Access Compliance Report Public Rights-of-Way (Curb Ramps)

Main Street: TUDOR_WAY Cross Street: DOWNING_ST Location: E

ADA ID: RPAT211103131600 Ramp Type: Type 4 - Parallel Initial Pass/Fail: Fail Overall Compliance: No Severity Score: 2

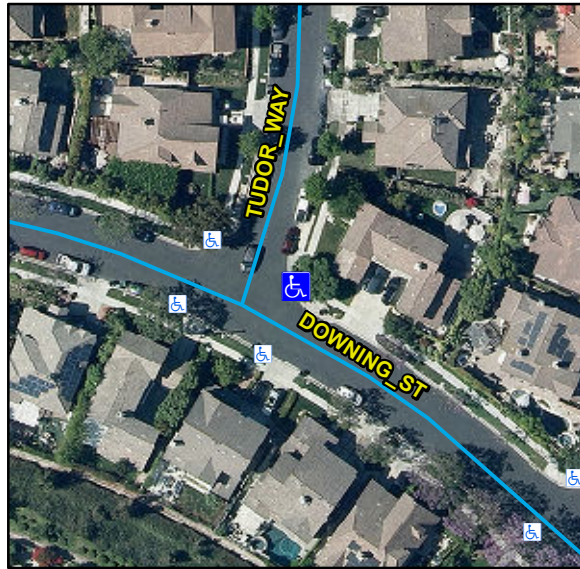
Compliance	Description	Data	Compliance	Description	Data
N/A	Ramp Length LT (in)	90	N/A	Ramp Length RT (in)	83
Yes	Ramp Width LT (in)	49	Yes	Ramp Width RT (in)	49
Yes	Ramp Run Slope LT (%)	3.2	Yes	Ramp Run Slope RT (%)	7
No	Ramp Cross Slope LT (%)	2.3	No	Ramp Cross Slope RT (%)	4.8
N/A	Landing Present	N/A	N/A	DWS Provided	N/A
N/A	Landing Length (in)	N/A	N/A	DWS Contrast	N/A
N/A	Landing Width (in)	N/A	N/A	DWS Length (in)	N/A
N/A	Landing Run Slope (%)	N/A	N/A	DWS Full Width	N/A
N/A	Landing Cross Slope (%)	N/A		DWS Offset Type	N/A
N/A	Landing Movement Obstructed?	N/A	N/A	DWS Offset Left (in)	N/A
	Landing Movement Type	N/A	N/A	DWS Offset Right (in)	N/A
N/A	Landing Shared	N/A			
N/A	Clear Space	Yes			
N/A	Clear Space To Crosswalk (in)	N/A			
N/A	Marked Crosswalk 1	No	N/A	Marked Crosswalk 2	No
	Crossing 1 Direction	NW		Crossing 2 Direction	SW
	Marked Crosswalk 1 Width (in)	N/A		Marked Crosswalk 2 Width (in)	N/A
N/A	Ramp Inside Crosswalk 1	N/A	N/A	Ramp Inside Crosswalk 2	N/A

Remove & Replace Curb Ramp With Two New Directional Ramps or Equivalent.
